Technical Note

Project: Land North of Rounds Gardens, Rugby

Subject: Transport Assessment Addendum

Client:	St Modwen Homes		
Project No:	05554	Version:	A
Document Ref:	TN-01	Author:	JW
Date:	26/06/2024	Approved:	JW

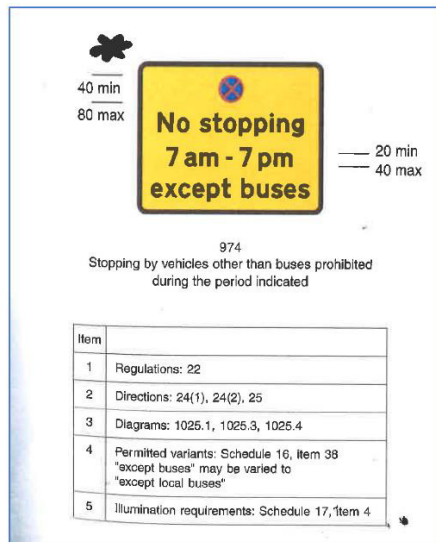
- Provide additional detail in respect of the lighting and all-weather surfacing of paths.
- Provide details of all connections between footways/ cycleways and vehicle routes such that it can be clearly shown that these will minimise conflict.
- Alter the 2m pedestrian footways shown in the proposed pedestrian/ cycle strategy to 3m shared footway/ cycleways (see blue lines on annotated plan below). The shared footways/ cycleways should be wider at junction points and include seating.
- Ensure that the pedestrian/ cycle access points include 3m footways/ cycleways and continuous, surfaced and lit connections (without barriers) to York Street, Blackman Way/ Rounds Gardens, Hill Street and Essex Street (see blue lines on annotated plan below).

- The paths within the public open space will be hoggin paths, as specified on the detailed landscape drawing (**Appendix C**);
- Lighting will be provided within the public open space. It is proposed that this will be dealt with by way of a lighting strategy secured by planning condition;
- The engineering details of the connections between the paths and estate roads are shown on the highway drawings within **Appendix C**;
- Seating is provided within the public open space as detailed on the landscape drawing; and
- The site layout has been updated to include connections to the site boundary as highlighted by WCC in Figure 1. At Essex Street, to the north-east of the site, the existing pedestrian gate at the boundary of the site will be removed to facilitate this connection.
